Project No. 4003-03
November 29, 2012

Reference: *Lake Van Norden Dam*
Nevada County, California

Subject: *Summary of Additional Spillway Repairs*

Photo 3 – Cold joint void between right abutment and spillway

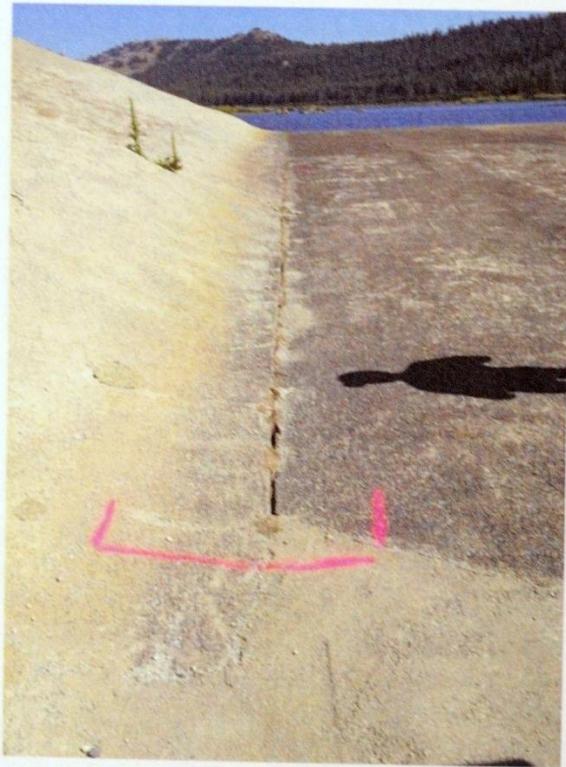
We also observed voids at the cold joint between the right abutment and spillway. Photo 3 shows the void at the cold joint and Photo 4 shows the area planned to be cut and filled with concrete.

5. Looking upstream at the right concrete wall of the notched section. A large hole is present to the right of the bottom of the wall, shown below.

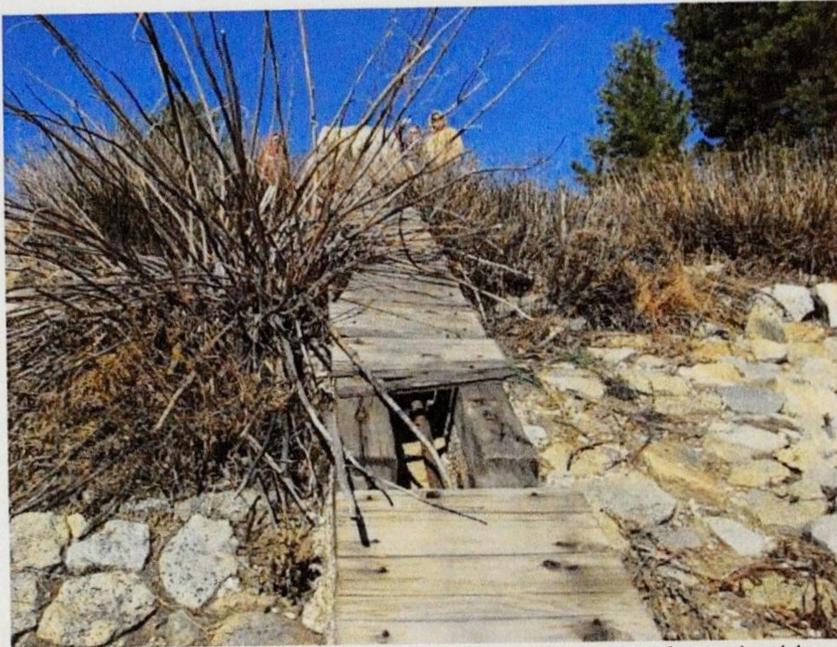
present. Everyone agreed with me that the hole needs to be fully backfilled with concrete. Longitudinal cracks on the left half of the concrete invert slab at the downstream end near the hinge point were also present. These cracks, located next to those repaired last year, will also need to be repaired. I requested Mr. Chuck Kull to devise a repair plan and submit it to DSOD for approval prior to implementation. The work is considered maintenance; therefore, no application would be required.

Mr. Kull submitted a repair plan by the 8/31/12 e-mail (and later a hard copy by mail). The proposed work includes filling the hole at the right side with concrete, saw cutting the cracked concrete invert and backfilling with new concrete to grade. We found the proposed work plan satisfactory, provided our comments noted in the 9/7/12 and 10/4/12 e-mails are adhered to. The work is scheduled to commence by the later part of October and to be completed in a couple days, weather permitting.
